**GRID CODE  
FURTHER CONSULTATION DOCUMENT**

**Generator Compliance**

Consultation Ref	A/10
Issue	1.1
Date of Issue	8 <sup>th</sup> February 2011
<b>Responses required by</b>	<b>8<sup>th</sup> April 2011</b>
Prepared by	National Grid

**Diagram of Relationship between Codes CP and OC5**

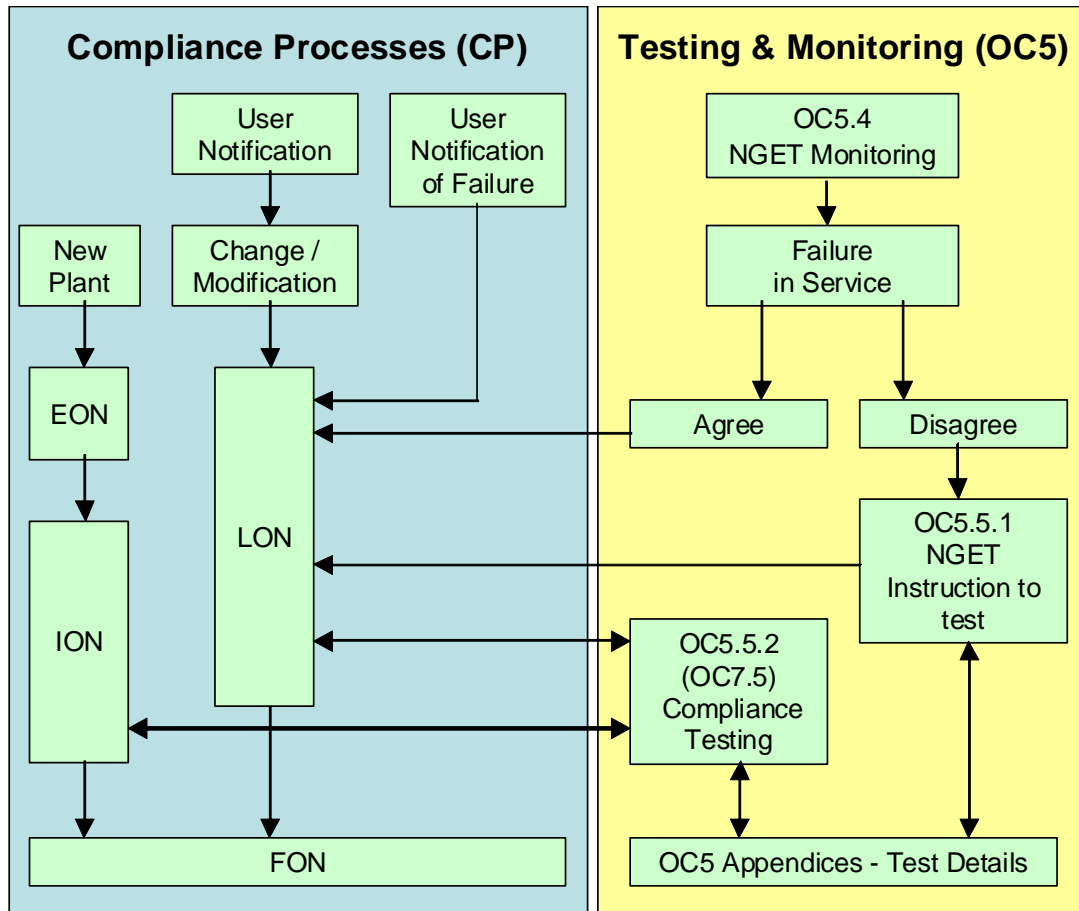
- 2.4 Operating Code 5 has been extended to cover generator tests to demonstrate compliance as well as the existing facilities for NGET instructed tests on Users following monitoring. Table OC5.5.3 has been redrafted to incorporate and harmonise all “pass criteria” from the existing table and the detailed testing appendices previously included in the Connection Conditions under the A/10 consultation. Four Appendices have been added to OC5. The first consolidates the lists of signals required for on-site monitoring (previously existing in OC5.5.2.2(a)-(e) and in the testing appendices of the Connection Conditions). The second appendix describes the tests preferred for Synchronous Generators whilst the third describes the tests preferred for Power Park Modules and the fourth for DC Converters. These three test description appendices have been created from CC.A.13 and CC.A.14 in the A/10 consultation by separating out the DC Converter requirements and relocation of the signal specifications to the CC, signal lists to OC5.A.1 and pass criteria to OC5.5.3. The wording for offshore Power Park Modules has been altered to make it clear that voltage control/reactive capability testing is required against any requirements in the Bilateral Agreement at the offshore Grid Entry Point.

- 2.6 The inclusion of the “Generator Build” option within the compliance processes has been achieved by a small number of additional references to “OTSDUW” and “OTSUA” mainly in CP.2 and CP.4. An additional section has been added to the User Data File Structure in the DRC to provide for the submission of the offshore transmission system data during design and commissioning prior to the transfer of assets and an additional paragraph added to OC5 (OC5.A.3.1.8). The application of these clauses are applicable until the “OTSUA Transfer Time”.

## Diagram illustrating relocation of Compliance Process from Connection Conditions

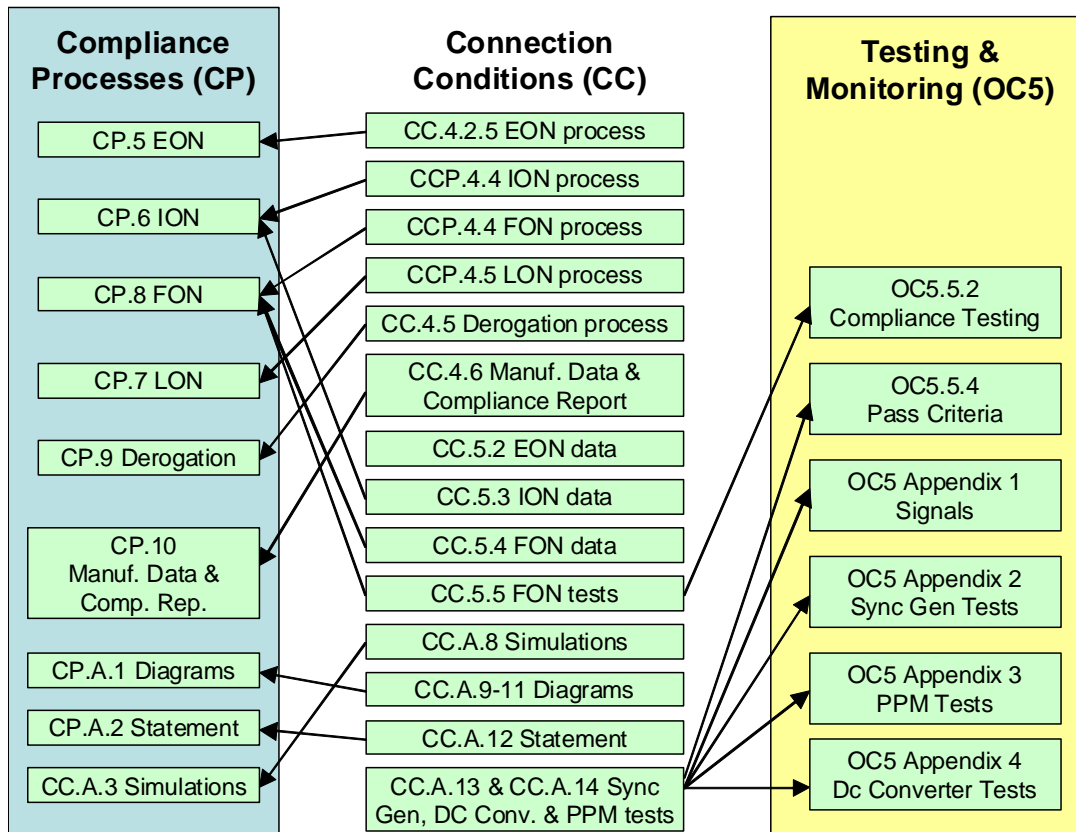
- 2.2 The Connection Conditions have had the process elements removed to the new Compliance Processes (CP). The items for submission prior to connection have been left unchanged in the Connection Conditions (CC.5.2) but could be moved to the CP if the User community wished. The requirement to provide signals for testing has been moved from the previously proposed appendix and added to CC.6.5 as this is a physical necessity that should be considered in plant design.

- 2.3 The Compliance Processes have been added as a new section to the Grid Code using text proposed by A/10 and from CC.5.2. In the general the individual paragraphs transferred to the “Compliance Processes” remain substantially unaltered but have been re-ordered to reflect the sequential nature of the underlying process. This has allowed a considerable amount of duplication and cross referencing to be removed when compared to the drafting contained in consultation A/10. This streamlining to improve readability has merged the process description with the testing and submission of information appropriate for each stage. The overall structure is now:
